Sheet: /	
File: HC ohm tester.kicad_sch	
<b>Title:</b>	
Size: A4	Date:
KiCad E.D.A. 9.0.0	Rev:
	Id: 1/1

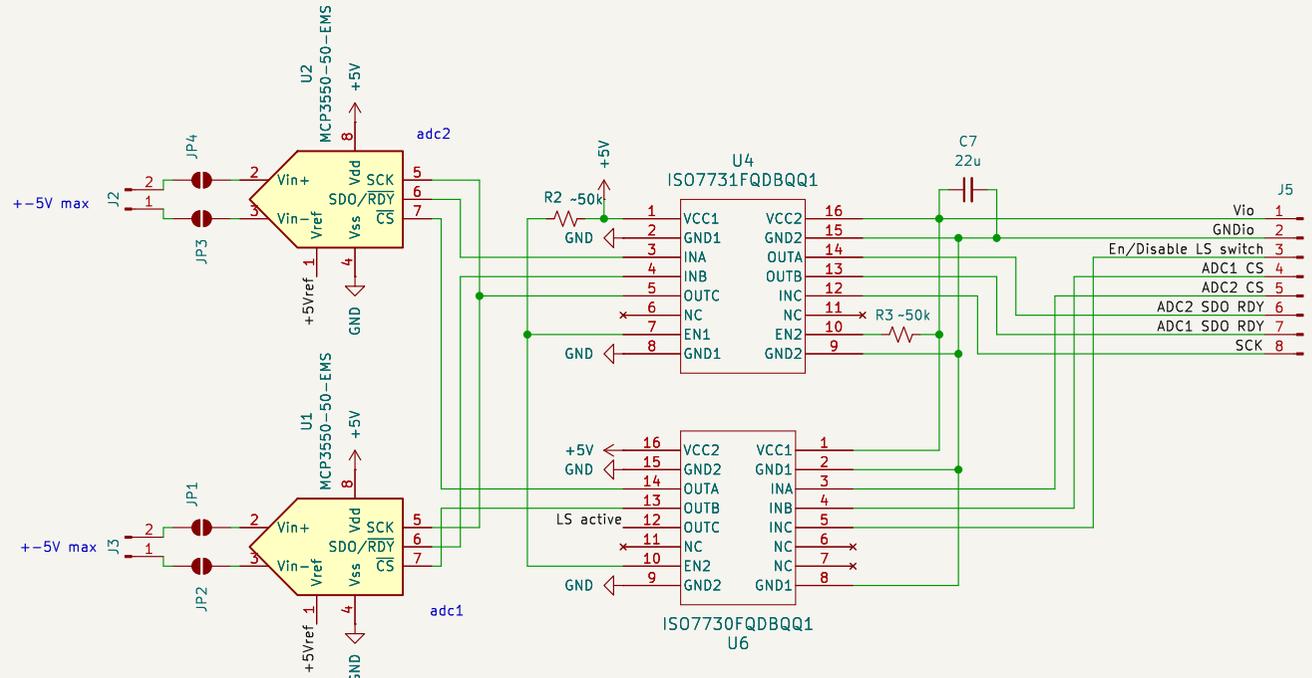
to reduce stress & emi.  
high current inductors are expensive.  
attach one yourself  
-6uL  
fet will be fighting for its life regardless

super caps are a cheaper alternative but I think too dangerous
